ADDENDUM
PLANNING DIVISION REPORT
DEPARTMENT OF PLANNING AND COMMUNITY
AND ECONOMIC DEVELOPMENT
Of July 30, 2008

RE: I.D. #10643: Zoning Map Amendment I.D. 3367 To Rezone 515 S. Midvale Boulevard from PUD-GDP to PUD-SIP

SUBJECT: **Referral of 515 South Midvale Boulevard – PUD (GDP-SIP) – Staff Comments on Plan Commission Referral to Review Plans for Midvale Blvd Driveway Alternative**

TO: Members of the Plan Commission
FR: Concerned Neighbors of Sequoya Commons c/o Bonnie McMullin-Lawton
Date: July 23, 2008 (CNAC)
RE: Sequoya Commons Phase II

CNSC
EXHIBIT

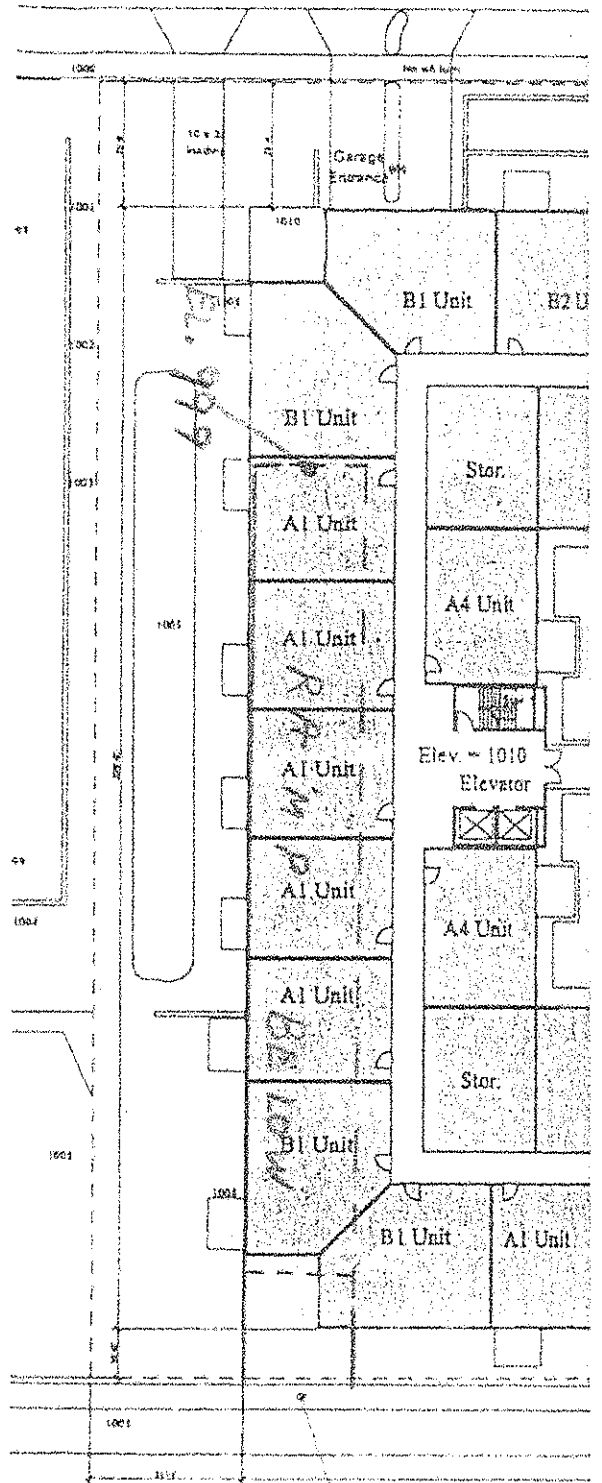
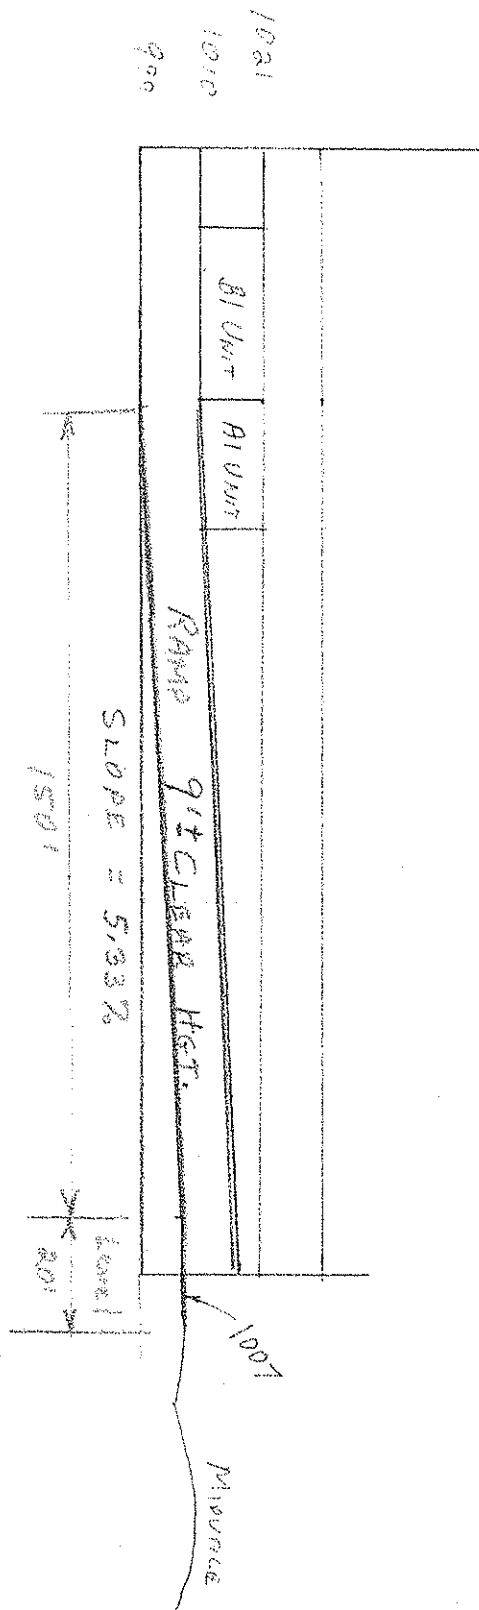
A sketch prepared by Mr. Reichel of a potential Midvale Blvd entrance to Phase II **internal** to the building with a slope of 5.33%.

First, Mr. Reichel has designed an interior garage entrance from Midvale into the underground parking. It is shown with a 5.33% grade and is 150' long. However that length could be lessened with a steeper grade. The advantages to an interior entrance are that it is not open to the elements and it preserves the maximum greenspace. The downside is that it would reduce the number of parking spaces and would impact some of the first floor apartments, as shown in your materials. Fewer apartments and parking spaces would be impacted with a shorter, steeper driveway.

Sequoyia Commons Phase II
views of north
Medvale Heights apartments

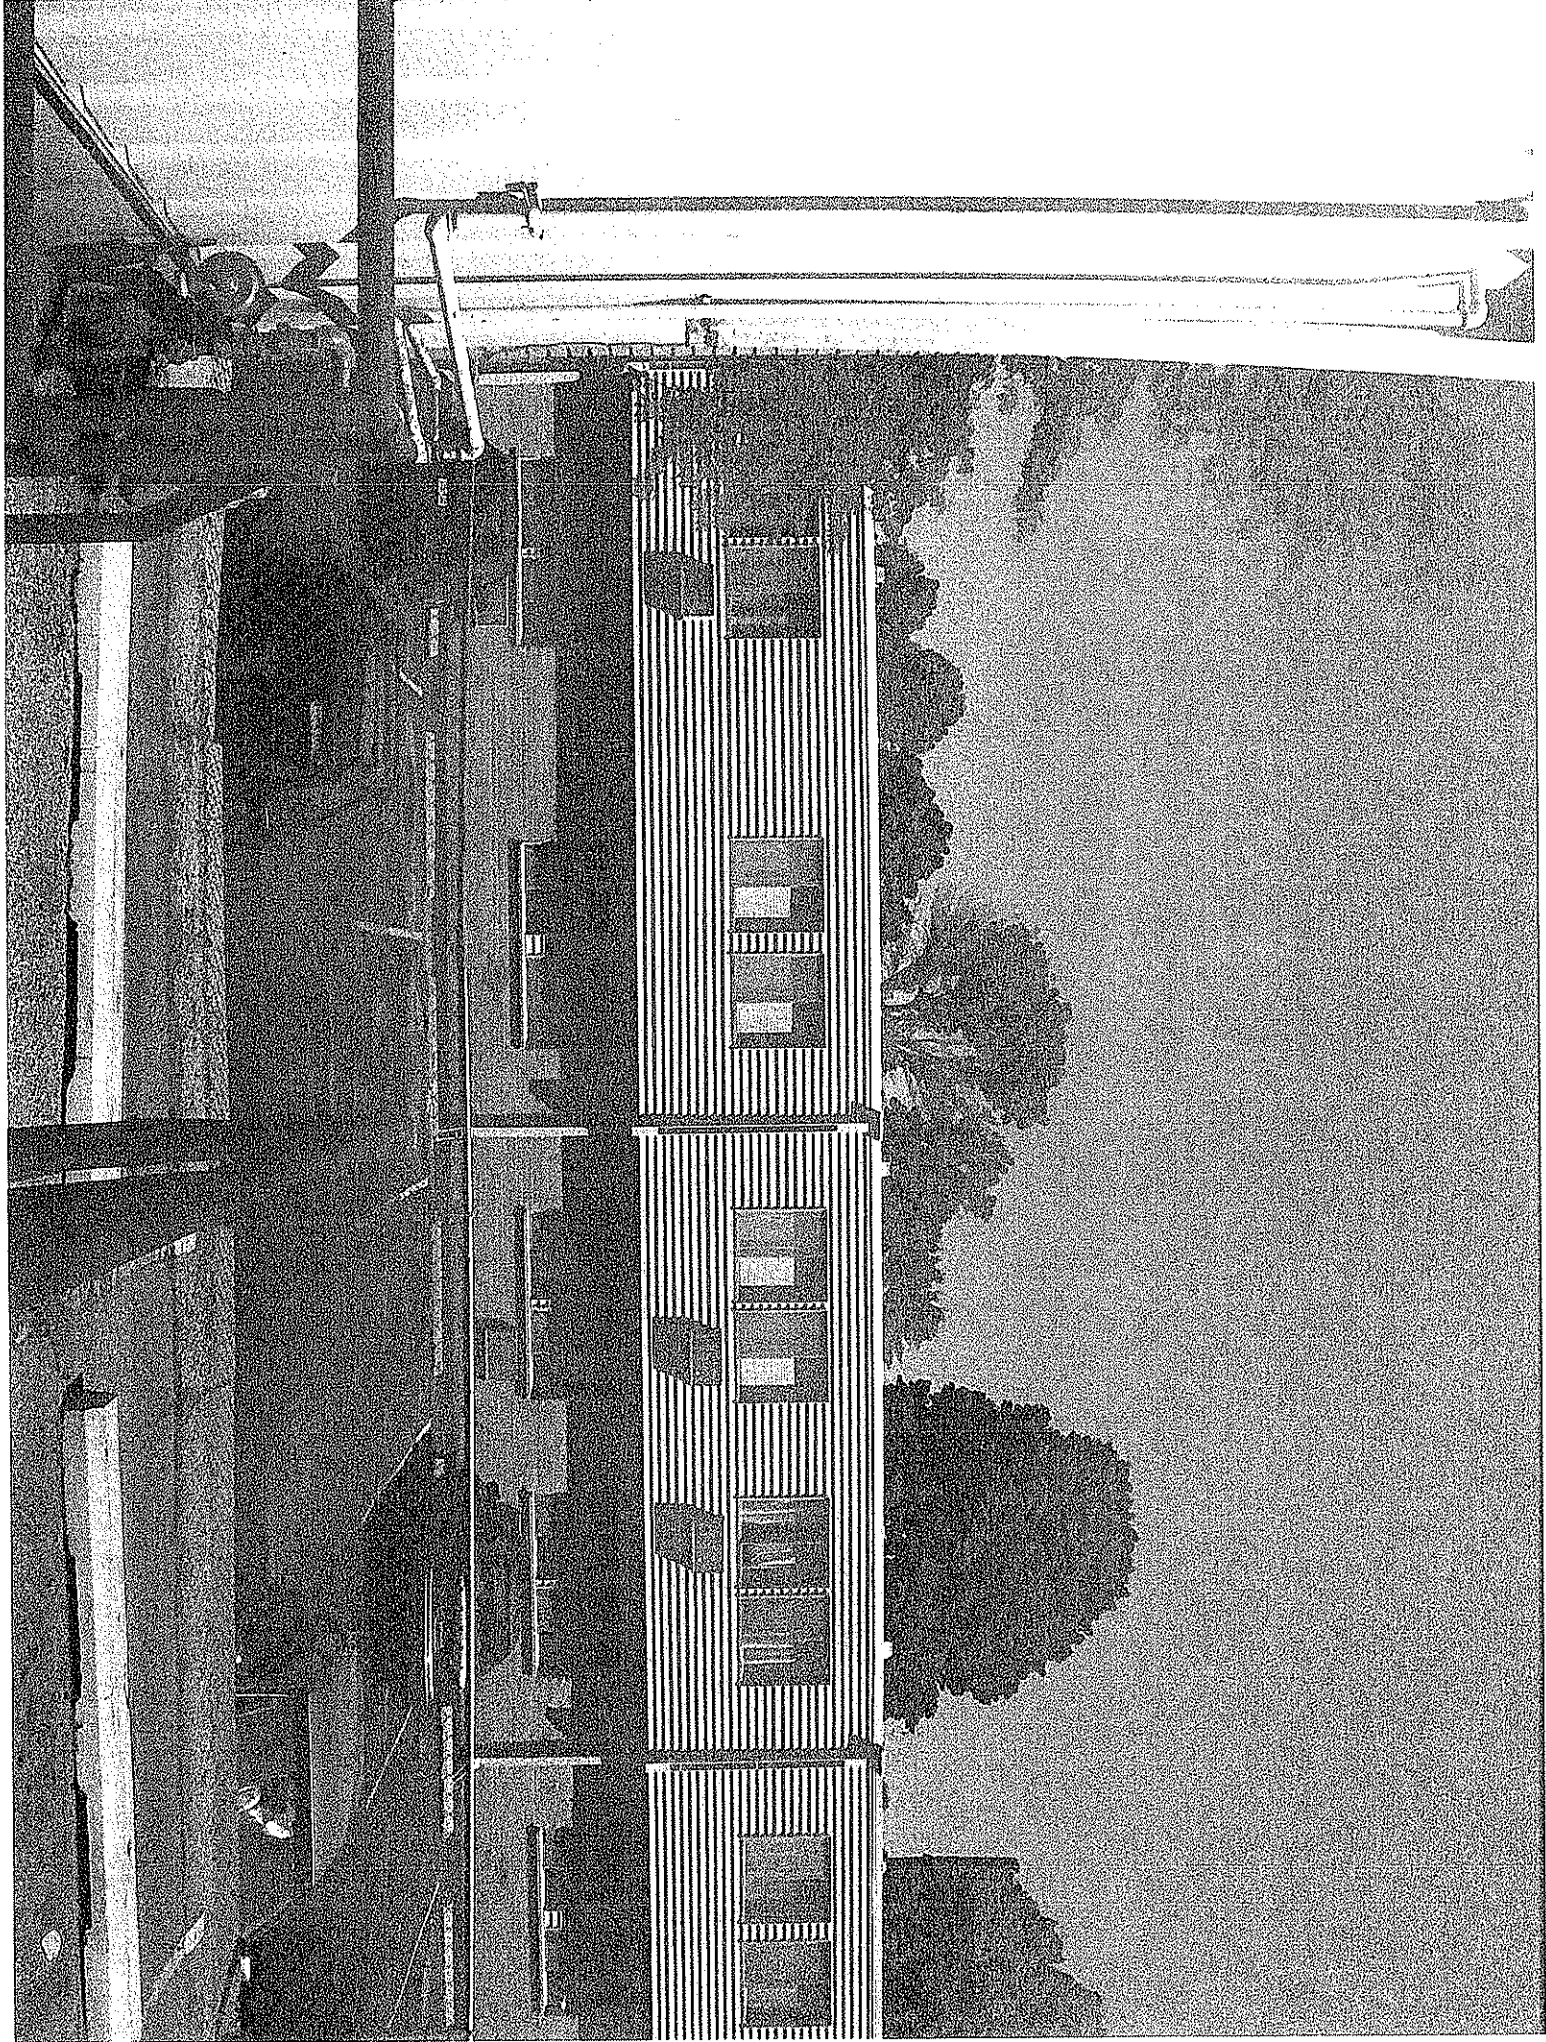
For the first 1/3 of the site from Midvale Blvd, that view will be of the Midvale Heights greenspace. For the remaining 2/3, it will be of the M.H. parking lot and building – more of the roof from the higher floors. I'm sorry this is relatively small and I will hand it over to be passed around if you'd like, but I took this photo 30' back from the lotline, on a two stair landing behind the existing retail. This is at a considerably lower elevation than the first floor of the new building will be but gives you a sense of the view of 2/3 of the north side residents.

30' from lot lines
standing of 2-step landing
behind current retail

Lower elevation than 1st flr windows
of new bldg.

This is the view of 2/3 of north side
residents of new S.C.
